# NORTH SYDNEY COUNCIL

**RE: 41 McLaren Street North Sydney State Significant Development - New School  
Development Application SSD - 46014456**

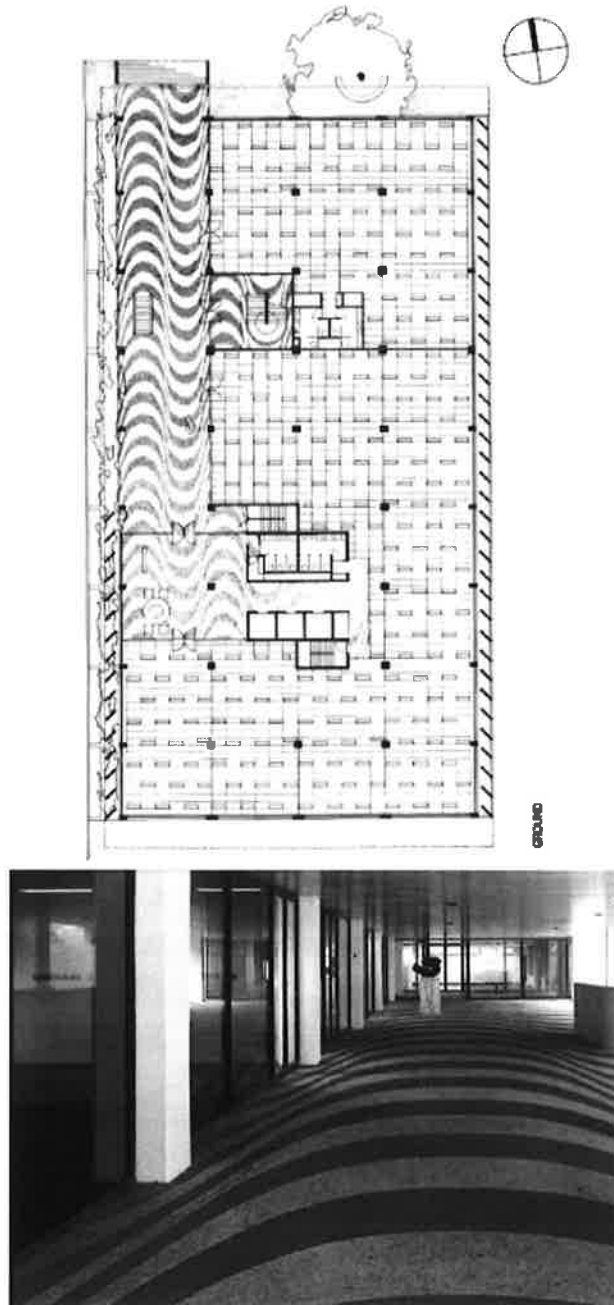
Changes to the South Elevation are acceptable and include a new glazing and frames, new handrail on top of the concrete block wall, roof top screening and additional louvres. Changes to the glazing systems will be sympathetic to the existing, being a dark aluminium framing with dark tinted glazing. This will retain the recessive effect of the original glazed facade elements.
